**EL PASO WATER UTILITIES
PUBLIC SERVICE BOARD**

ADDENDUM NO. 2

**JOHN T. HICKERSON WRF
HEADWORKS BARSCREEN REPLACEMENT**

BID NO. 40-23

**ELECTRICAL
DEMOLITION
PLAN**

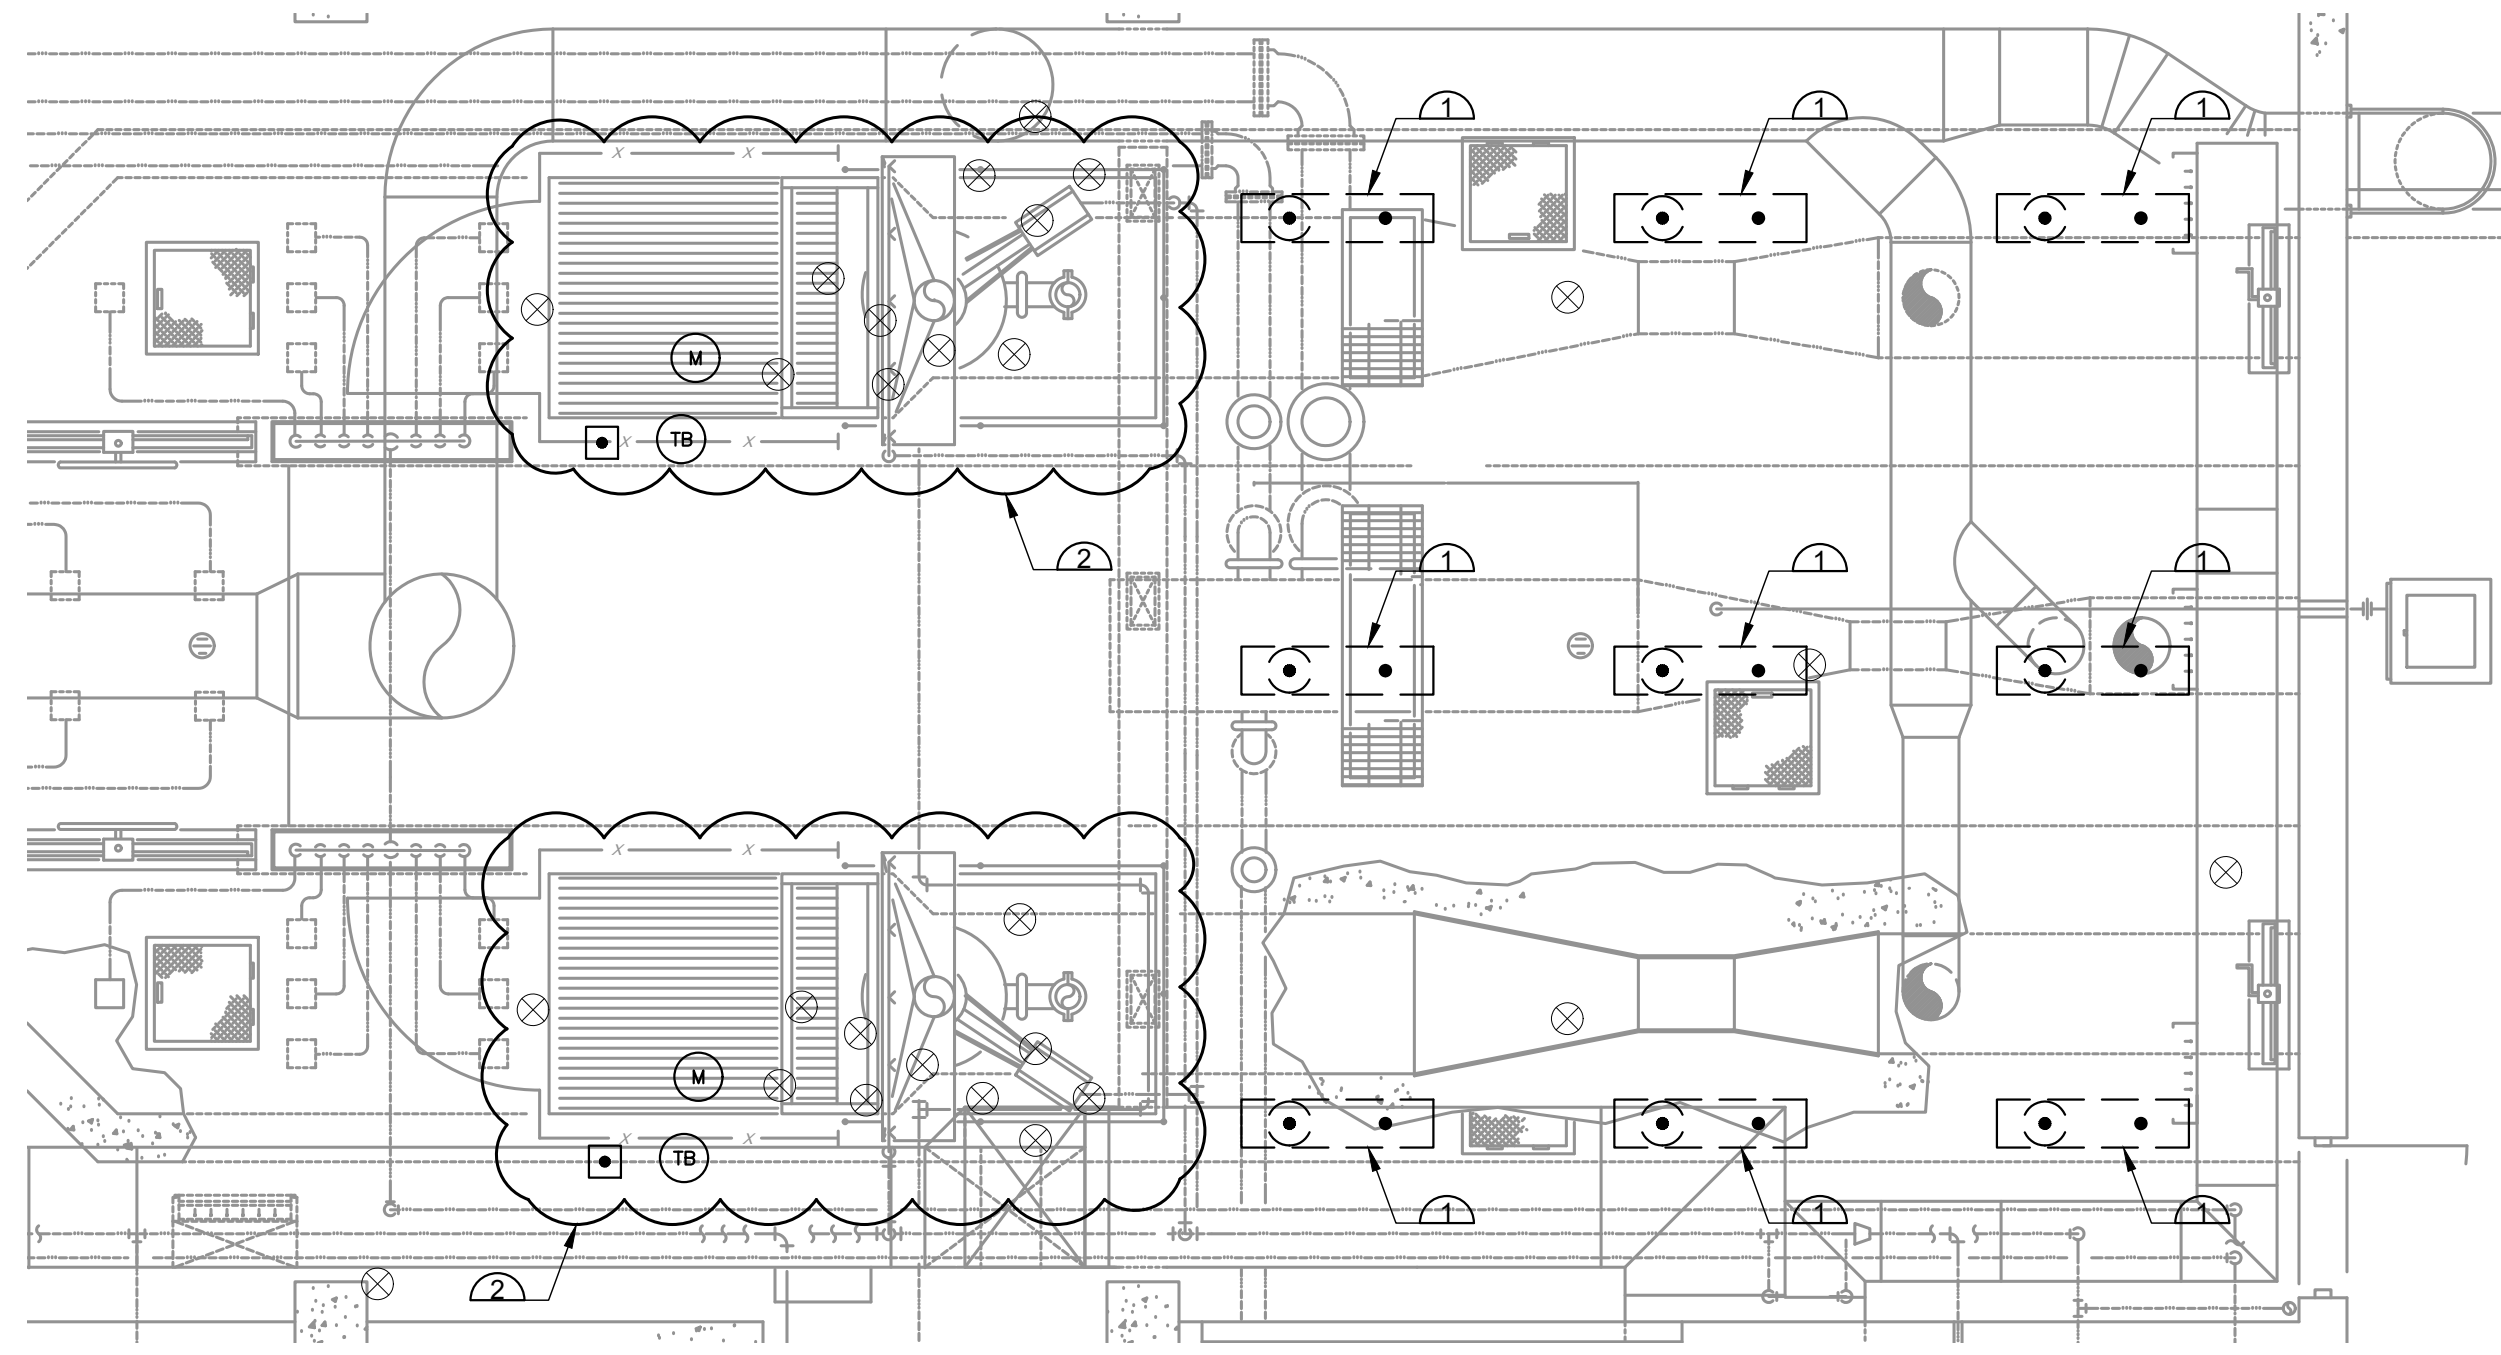
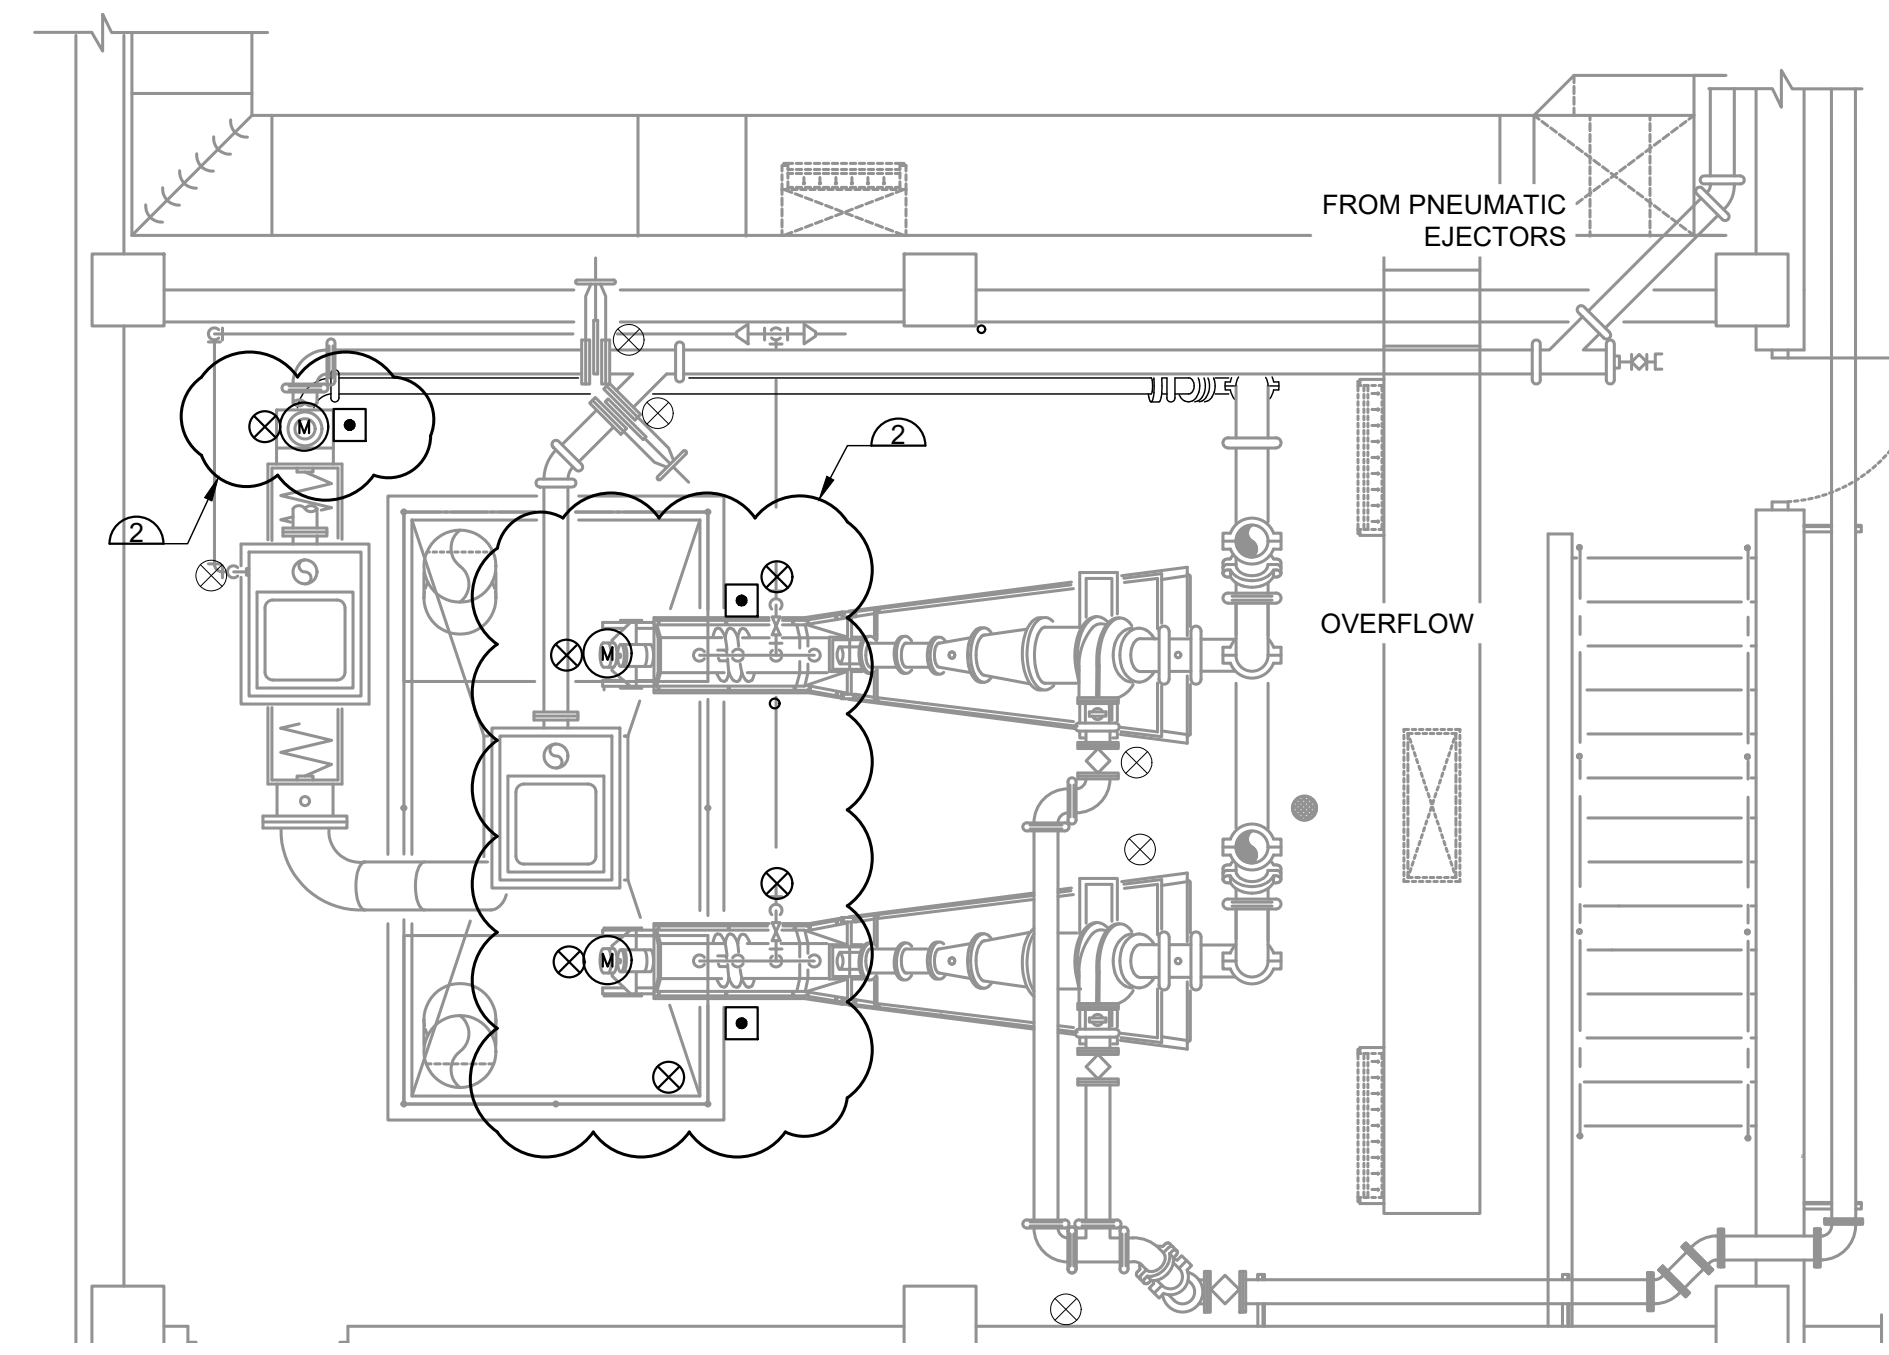
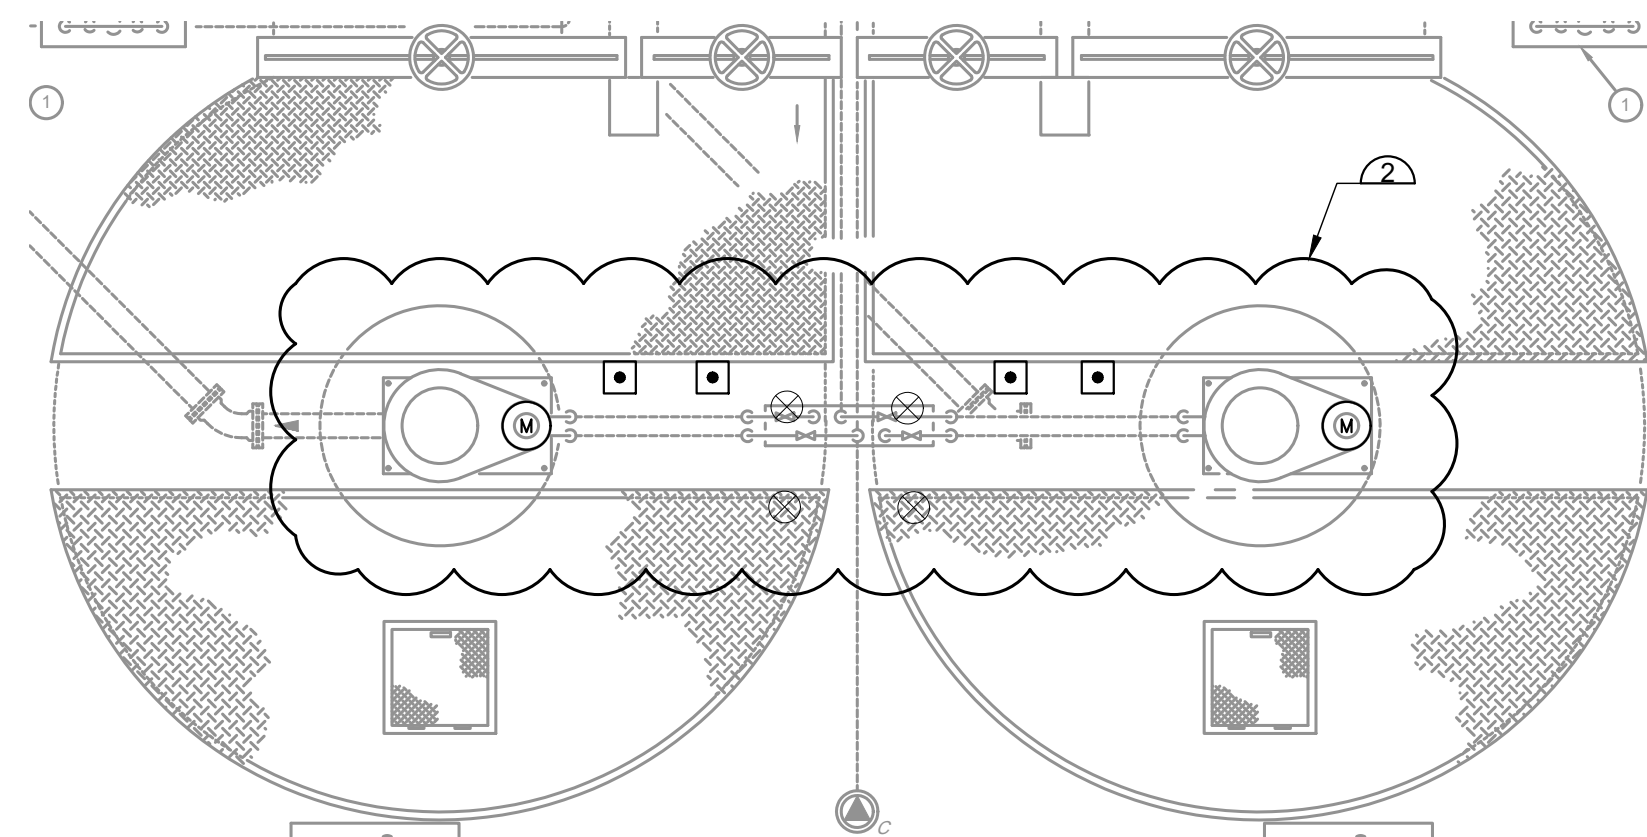
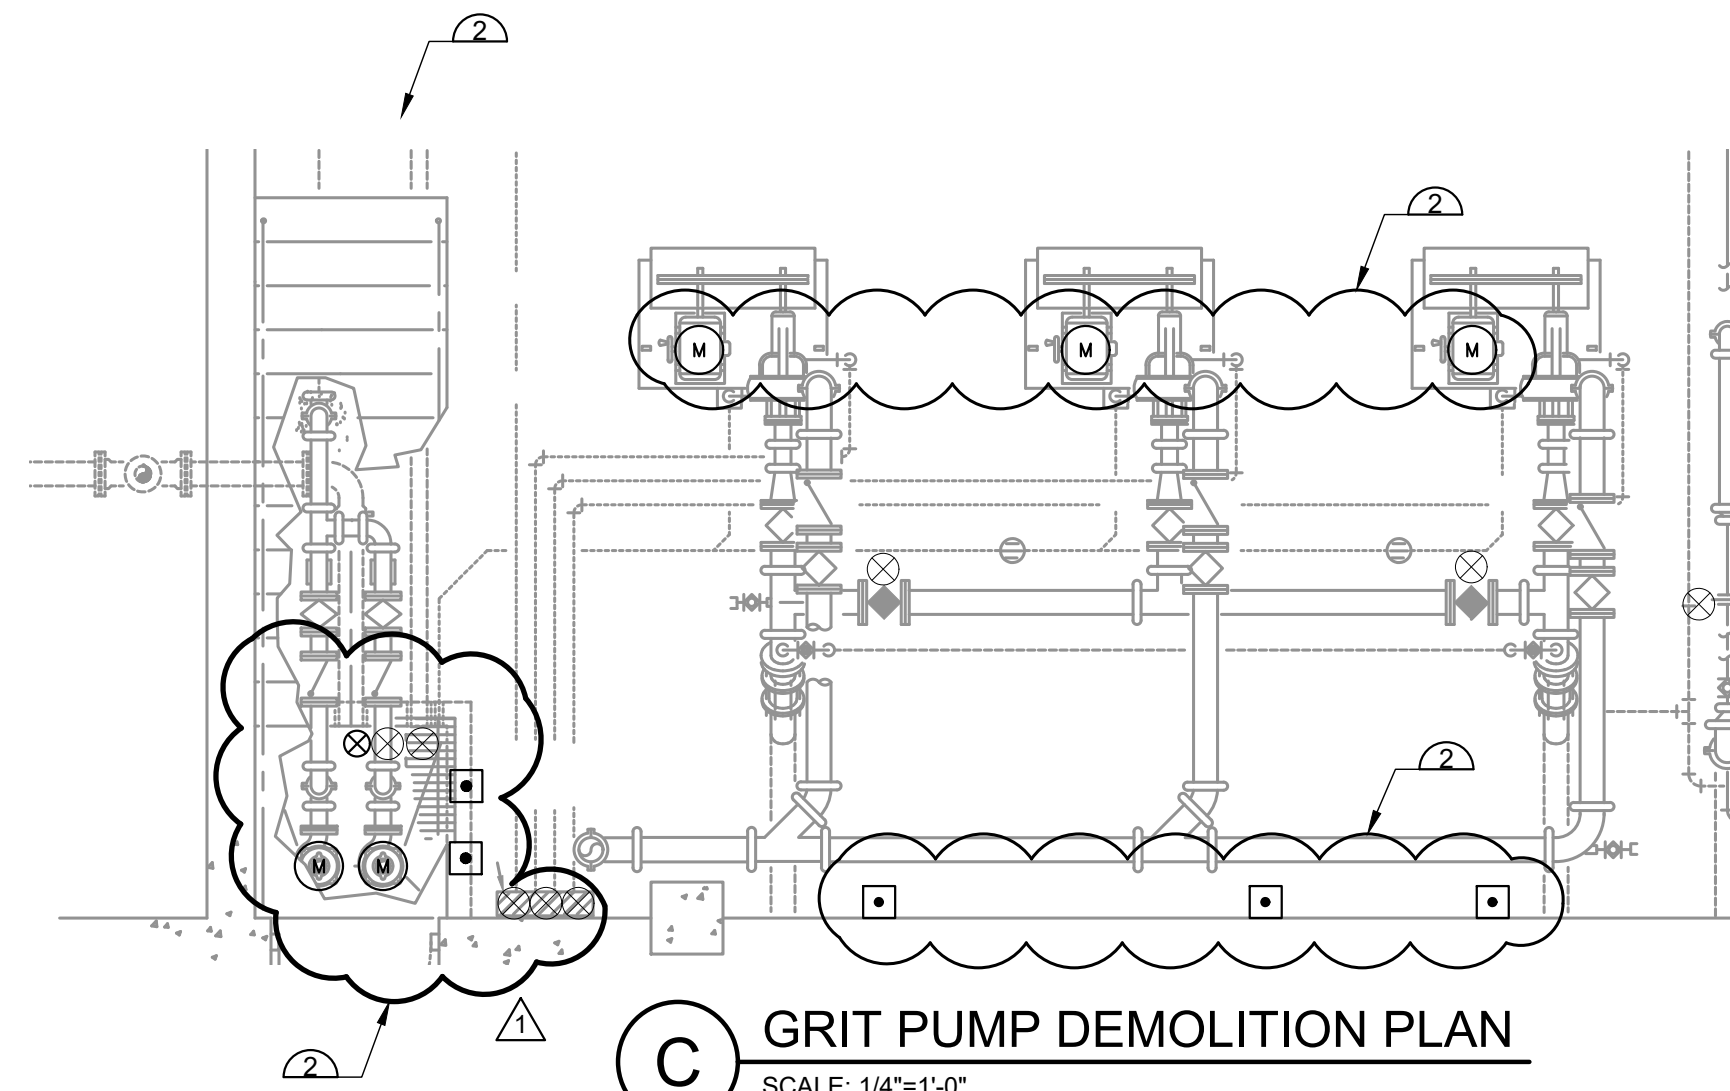
- AD-2.26. SHEET E004 – ELECTRICAL DEMOLITION PLAN
- A. REMOVE Sheet E004 in its entirety and REPLACE with revised Sheet E004 attached to this Addendum. Changes reflect demolition of Grit Room sump pumps.

Q-2.04. Sheet M106, Plan E – Grit Pumping Room Partial plan indicates the existing sump pumps are to be removed and replaced. Sheet E004, Plan C – Grit Pump Demo Plan does not show demolition of the sump pumps. Sheet E009 does not show electrical work being required for the sump pumps. Is electrical work required?

A-2.04 Electrical work will be required. See Addendum Drawings for electrical demo and replacement work related to replacement of Grit Pumping Room sump pumps.
